# Product Change Notification

Date Issued :	November 07, 2022	PCN Number :	512968
Reason for Change :	Change Supplier		
Description of Change :	Supplier Change : this notification is to inform you about a change of suppliers impacting the part(s) attached as per list. No changes will be made to product as part of this change.		
Reason for Short Notice :	Special Request		
Assessment of Change :	Reliability Test Report/s		
Planned Implementation Date :	January 01, 2023		
Sample Availability Date:	November 02, 2022		
Internal Molex Qualification Date :	November 02, 2022		
Last date to request Samples by Customer :	December 11, 2022		
Traceability Code Markings / Date :	Lot information on label

## Change Overview

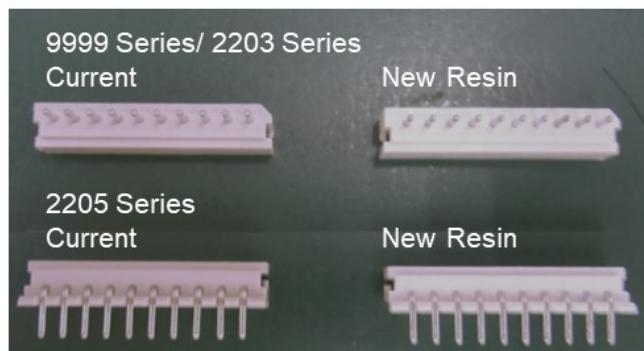
- Color difference

After changing the resin, the color will be slightly brighter.
